Subject: AP1000 Response to Request for Additional Information (SRP 3)

RAI-SRP3.7.1-SEB1-18

RAI Response Number: RAI-SRP3.7.1-SEB1-18
Revision: 0

Figure RAI-SRP3.7.1-SEB1-18-1 – In-Column Response Spectra at the Basemat Elevation

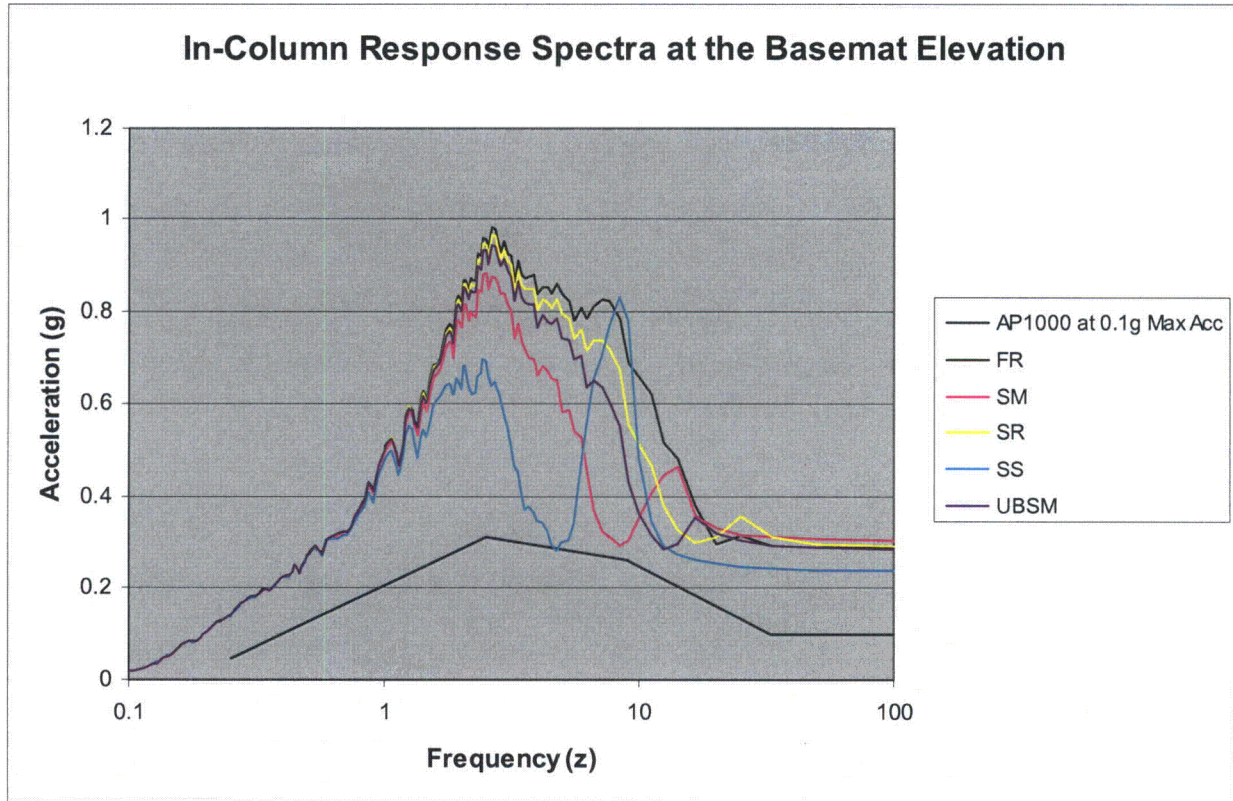
AP1000 DCD, Revision 17, Section 3.7.1, "Design Response Spectra," states that the design response spectra are applied at the foundation level in the free field at hard rock sites and at the finished grade in the free field at firm rock and soil sites. NRC Regulation, 10 CFR Part 50, Appendix S, requires that the horizontal component of the SSE ground motion in the free-field at the foundation elevation (i.e., bottom of foundation) have a peak ground acceleration of at least 0.1g together with an appropriate response spectrum. NRC Standard Review Plan Section 3.7.1 provides additional information in this regard. Given that the AP1000 CSDRS is applied at the finished grade for firm rock and soil sites, the staff cannot make a determination of the PGA and associated response spectra at the foundation elevation in the free-field for each of the generic sites used to evaluate SSI effects.

To address the above regulatory requirement, the staff requests that the applicant provide free-field in-column response spectra and associated PGA generated for each of the generic site columns (firm rock and soil sites) considered.

As requested by the NRC staff, Westinghouse has plotted the in-column response spectra at the basemat elevation for each of the generic sites. As seen from the plots given in Figure RAI-SRP3.7.1-SEB1-18-1 the peak horizontal ground acceleration (PGA) are all above 0.1g.
